Access Compliance Report Public Rights-of-Way (Curb Ramps)

Intersection ID: 14982 Main Street: ARENA_BV Cross Street: COLISEUM_DR Location: NE

ADA ID: DFC0C912546D Ramp Type: Perp Initial Pass/Fail: Fail Overall Compliance: No Severity Score: 33.75

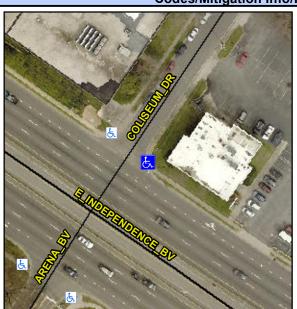
Not Found, R304.5.1, R304.2.2

Field Measurements/Component Compliance					
Compliance Description		Data	Compliance Description		Data
N/A	Ramp Length (in)	48.0	No	Ramp Slope (%)	17.6
No	Ramp Width (in)	44.0	Yes	Ramp XSlope (%)	0.1
N/A	Flare Type LT	N/A	N/A	Flare Type RT	N/A
N/A	Flare Slope LT (%)	N/A	N/A	Flare Slope RT (%)	N/A
N/A	Flare Traversable LT?	N/A	N/A	Flare Traversable RT?	N/A
N/A	Landing Length (in)	N/A	N/A	DWS Provided?	N/A
N/A	Landing Width (in)	N/A	N/A	DWS Contrast?	N/A
N/A	Landing Slope (%)	N/A	N/A	DWS Length (in)	N/A
N/A	Landing X Slope (%)	N/A	N/A	DWS Full Width?	N/A
N/A	Landing Curb? (Y/N)	N/A	N/A	DWS Offset (in)	N/A
N/A	Shared Landing?	N/A			
N/A	Gutter Ponding?	N/A	N/A	Gutter Slope (%)	N/A
N/A	Gutter Lip Ht (in)	N/A	N/A	Gutter X Slope (%)	N/A
N/A	Painted X Walk1?	No	N/A	Painted X Walk2?	N/A
	X Walk 1 Direction	To NW		X Walk 2 Direction	N/A
N/A	X Walk 1 Width (in)	N/A	N/A	X Walk 2 Width (in)	N/A
	X Walk 1 Slope (%)	0.2		X Walk 2 Slope (%)	N/A

Remove & Replace Entire Ramp.
